From: Colley, Jane
Sent: 21 January 2016 14:12
To: Planning (HPBC)
Subject: FW: McCormick HPK/2015/0651
Attachments: DY279095 and DY278201 boundary with plan SR074.1-001.docx

DY279095 (owned by E McCormick) and DY278201 (Planning Application HPK/2015/0651 site) boundaries

Location Plan SR074.1-001

DY279095 Land Registry Map

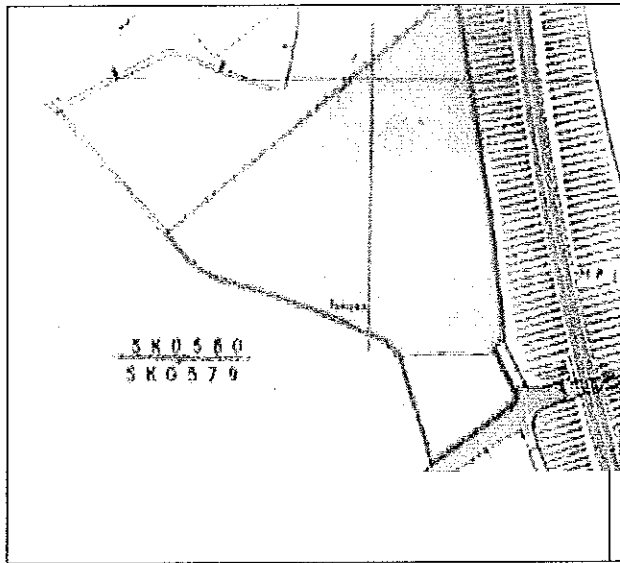
We have not received any formal notification from the applicant that the development will use part of DY279095 and yet the site plan does look as though it encroaches on to it.

DY278201 Land Registry Map shows the ditch to start on neighbouring property DY279095 owned by E. McCormick

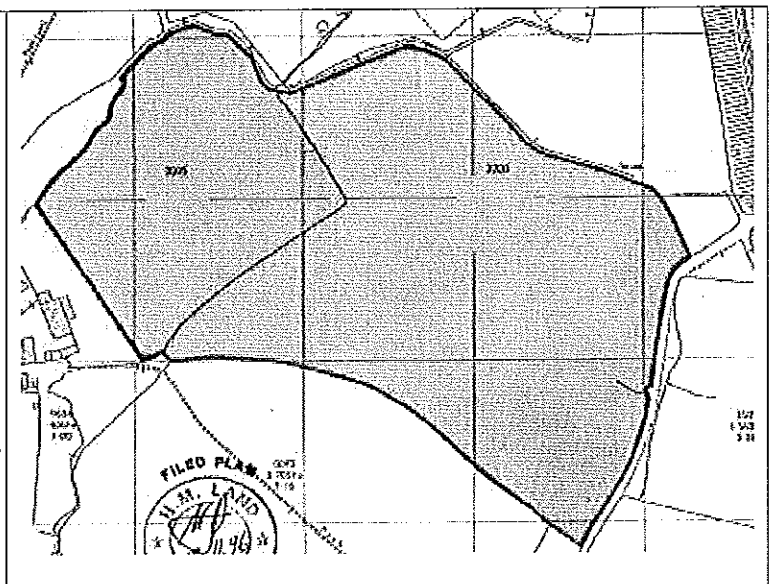
Suggested boundary according to some plans would place the ditch on the wrong side of the boundary

There is a noticeable difference in the shape of the boundary as entered in the planning documents versus the registered and fenced boundary.

Proposed Parameters Plan Drg.14-111-NP extract does not match the land registry plan

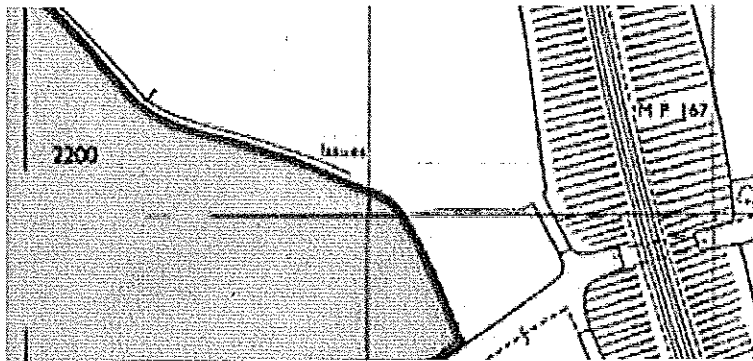
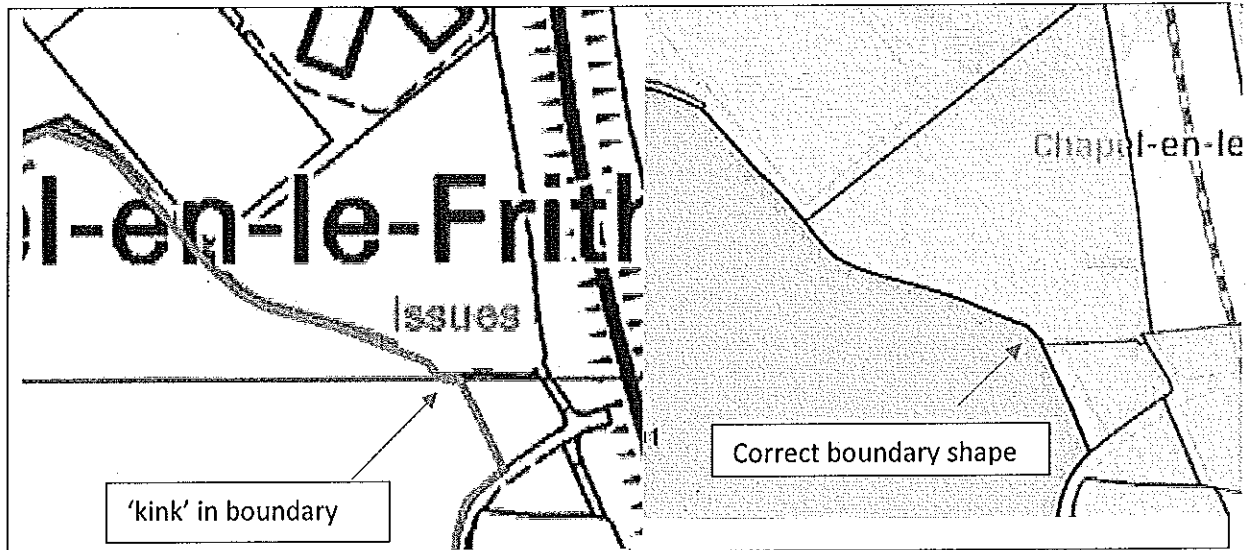
The site plan SR074.1-001 has a 'kink' in the boundary and appears to move the site boundary towards the railway line.

DY278201 is fenced on the south side of the hedgerow and the ditch is on the north side of the hedgerow in DY279095. Drains flow under the railway (under the archway) and cross DY279095 where a drain surfaces into an open ditch, it is not a spring as suggested in some of the planning application documents.

357193 Flood Risk Assessment Pt.1 extract

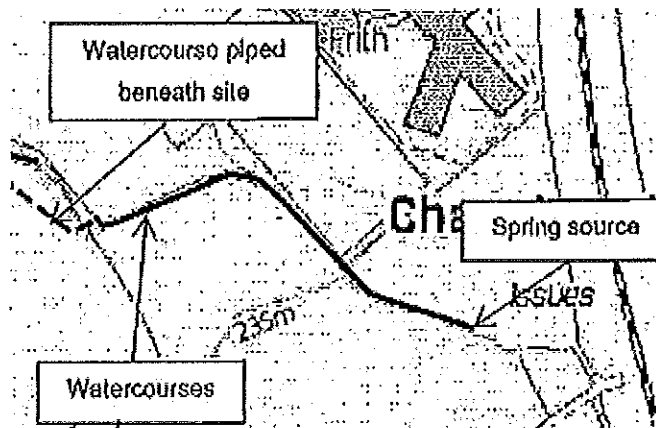
Exposed drainage pipe where a spring is suggested in the applicants Flood Risk Assessment.

357881 Revised Proposals post Neighbourhood Plan extract with the ditch shown incorrectly within the site boundary:-

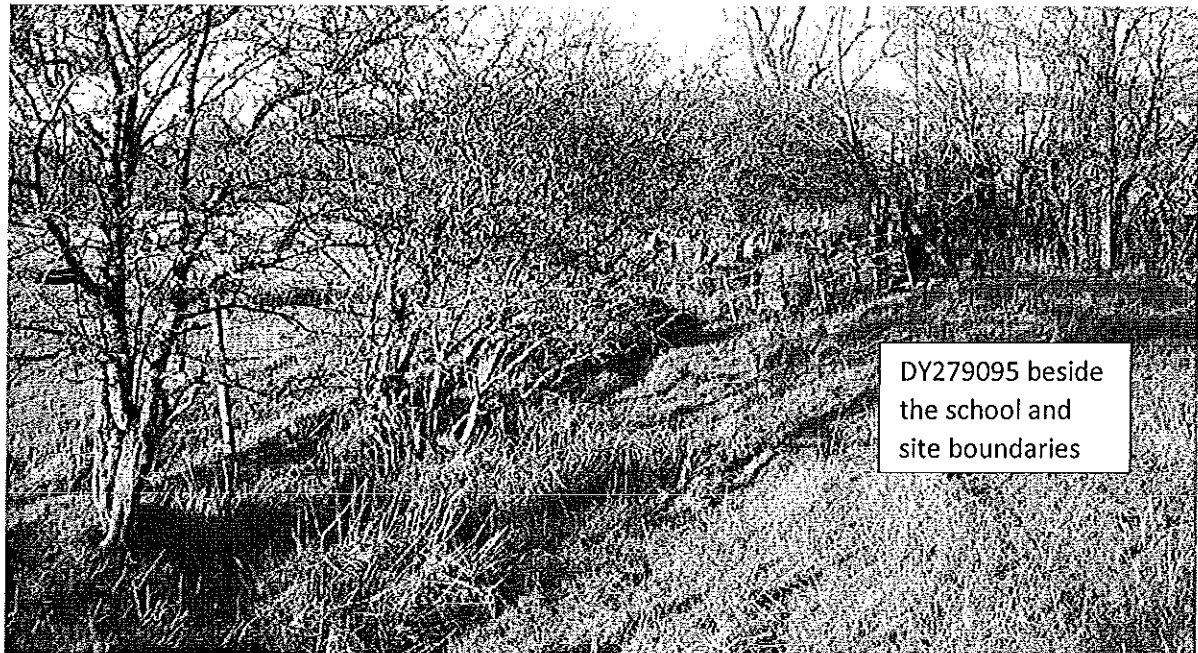
As can be seen in this next photograph where the school is visible in the background on the right hand top corner the ditch runs from DY279095 and goes behind the school with the boundary fence of the planning application site being to the south side of the ditch.

The boundary fence as it runs away from Bank Hall Drive towards the school has no 'kink' in it.
